Architect's Supplemental Instructions

Architect's ASI No: 066

Project:
Webster University
Interdisciplinary Science
Building

ASI-066 is being issued for relocation of site pole in Lot K.

E0001

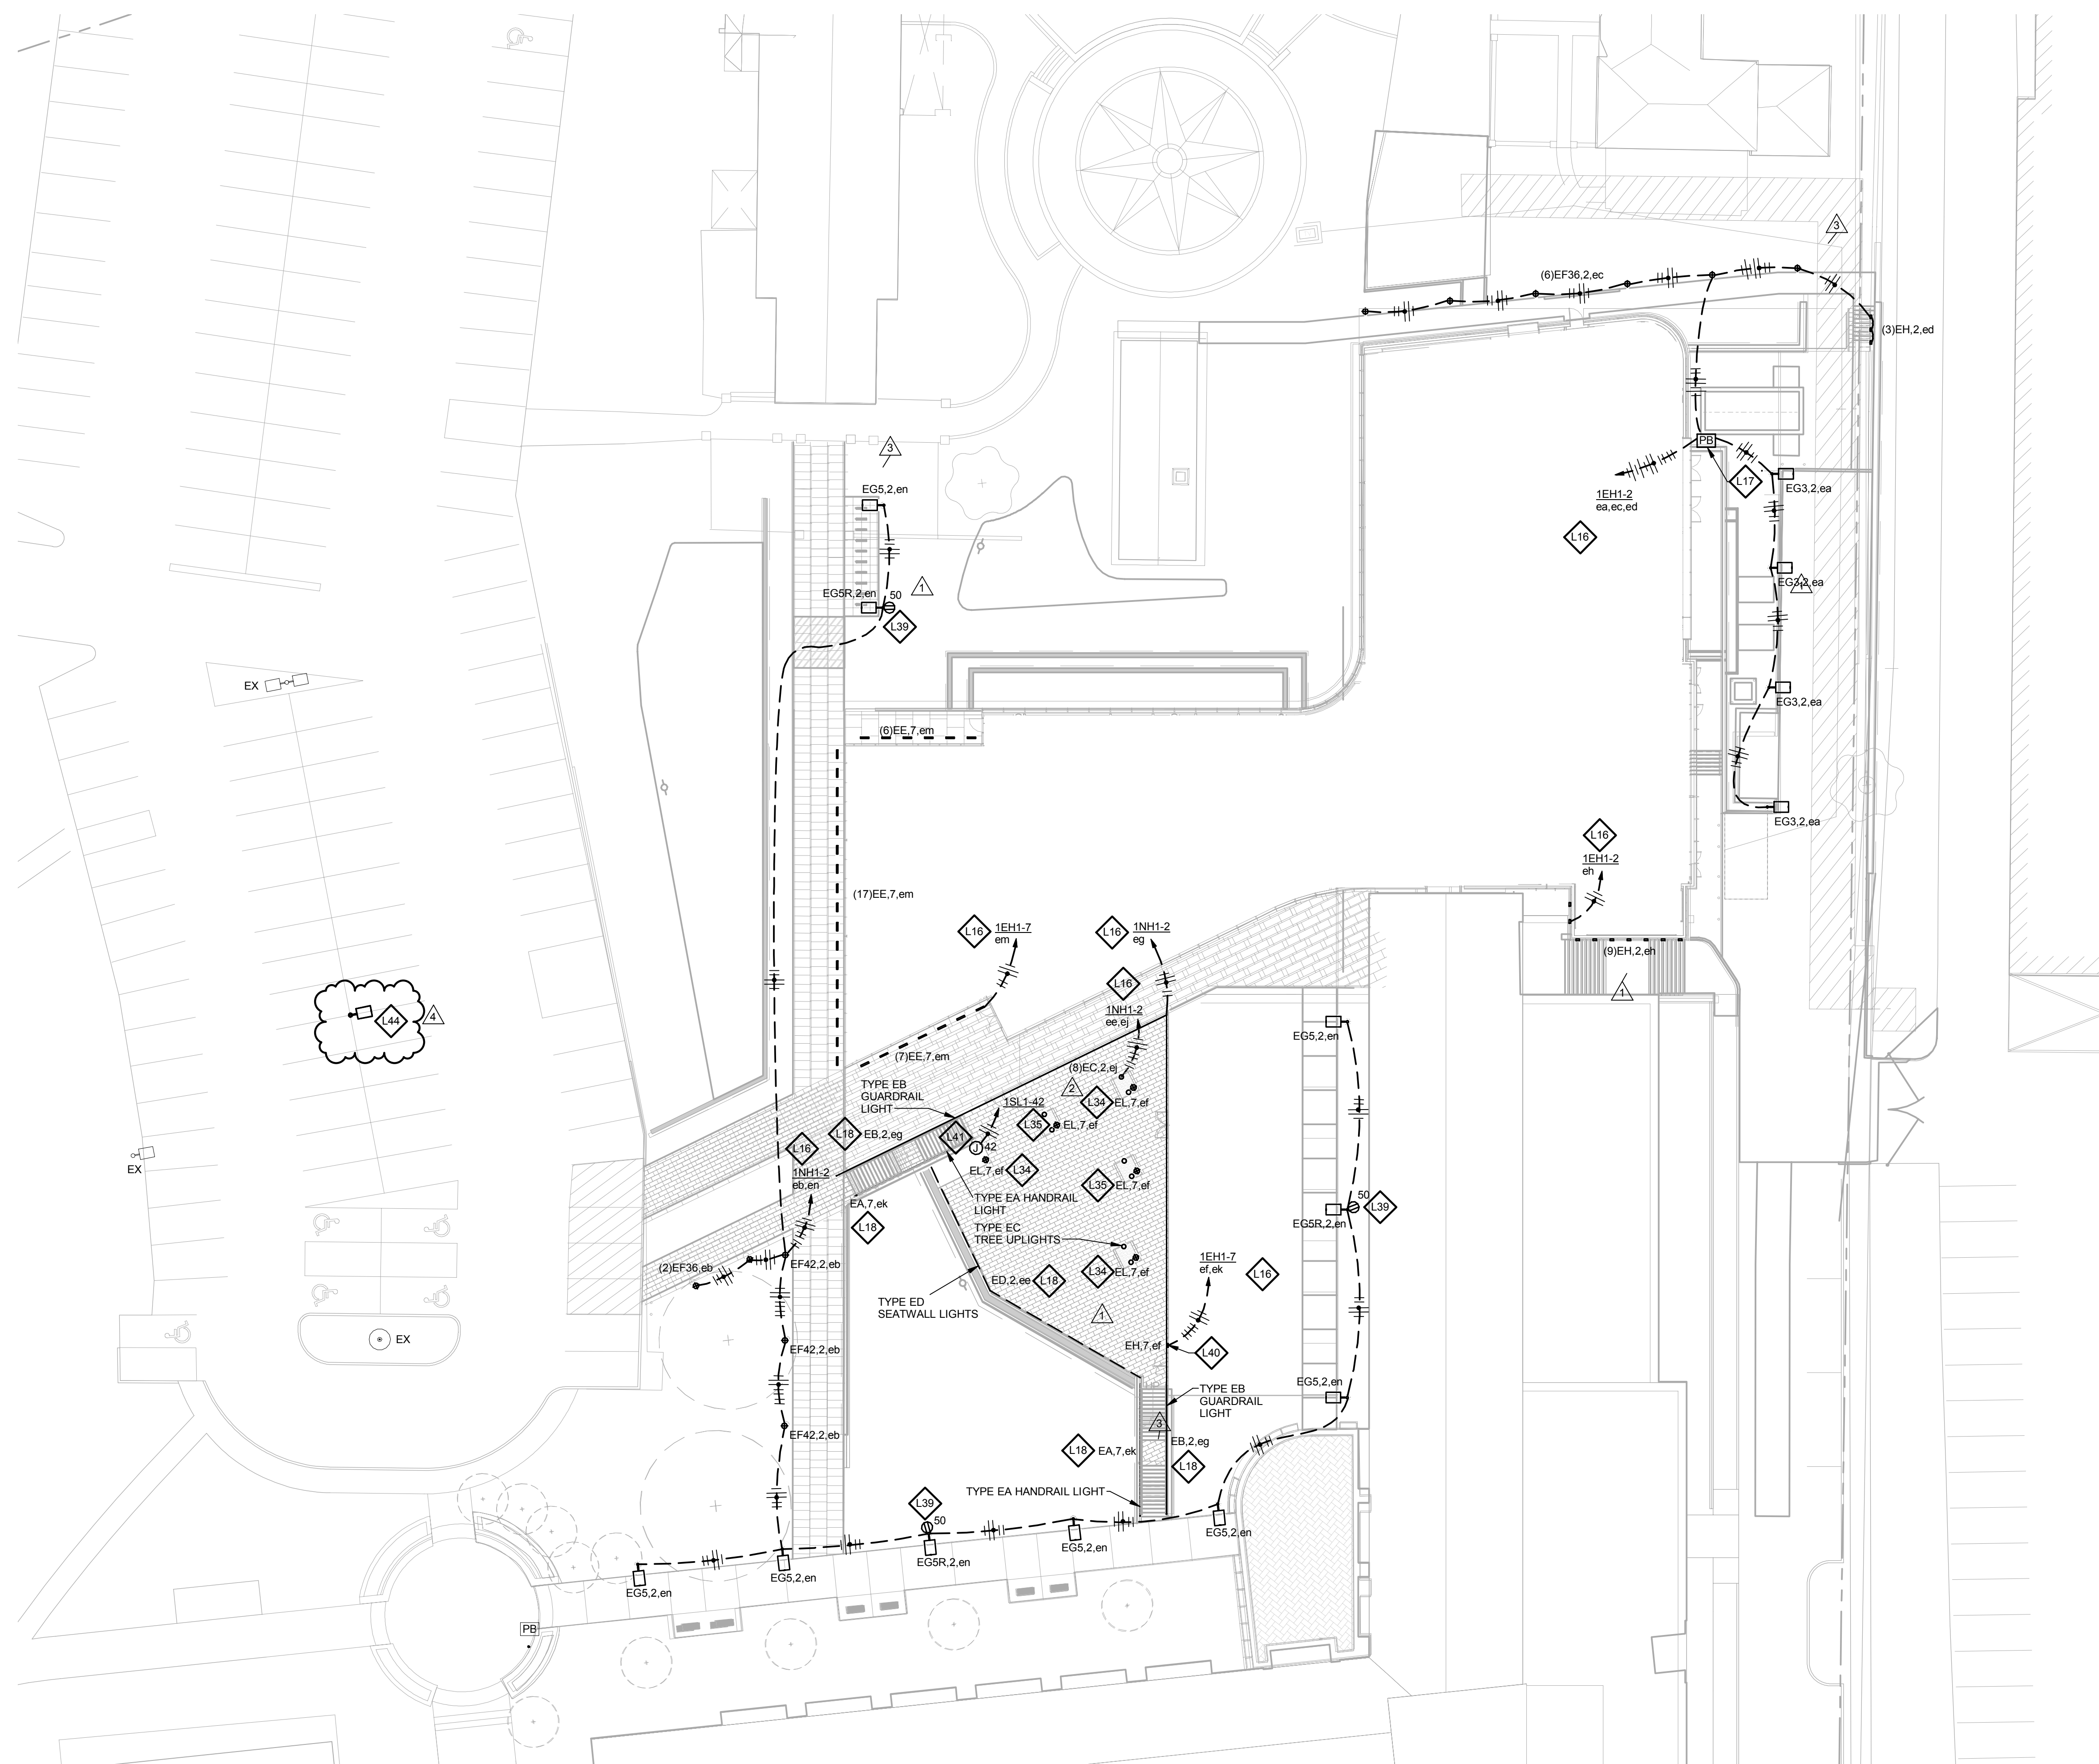
SHEET E0001 – ELECTRICAL SITE PLAN

- Relocate existing pole fixture on new concrete base. Intercept and connect fixture to existing circuit serving nearby parking lot lights. Modify and extend circuit as required.
- New concrete base dimensions shall match existing concrete base dimensions.

- L44 RE-LOCATE EXISTING POLE FIXTURE ON NEW CONCRETE BASE. INTERCEPT AND CONNECT FIXTURE TO EXISTING CIRCUIT SERVING NEARBY PARKING LOT LIGHTS. MODIFY AND EXTEND CIRCUIT AS REQUIRED. NEW CONCRETE BASE DIMENSIONS SHALL MATCH EXISTING CONCRETE BASE DIMENSIONS.
